# BULLETIN

NUMBER 181

November 5, 1959

SUBJECT: Replacement of 1/8 - 7 x 19 Flexible Stainless Steel Control Cables

PA-18A

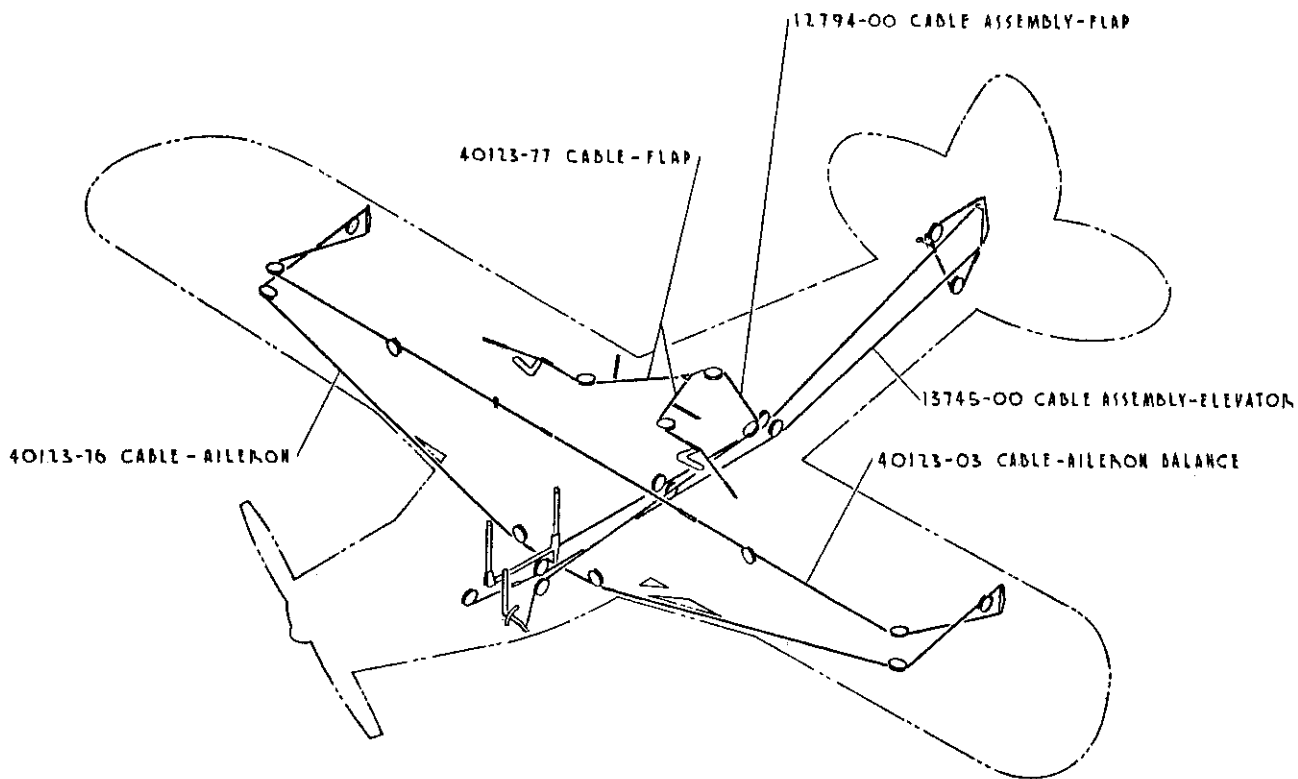
The following is a list of the affected control cables and their respective replacement parts which apply to the aircraft serial numbers listed after "MODELS AFFECTED", exclusive of the aircraft listed under Note "A". See sketches A, B and C for identification.

Replace Stainless Steel Cables		Qty. Req.	Nomenclature	Install Replacement Cables		Aircraft Application	
Part No.				Part No.	PA-18	PA-18A	
12794-03	1	Cable - Flap	12794-00	X			
13271-02	1	Cable - Flap	13271-00			X	
13745-02	1	Cable - Elevator, lower	13745-00	X		X	
40123-44	2	Cable - Aileron	40123-03	X		X	
40123-86	2	Cable - Flap	40123-77	X			
40123-87	2	Cable - Aileron	40123-76	X		X
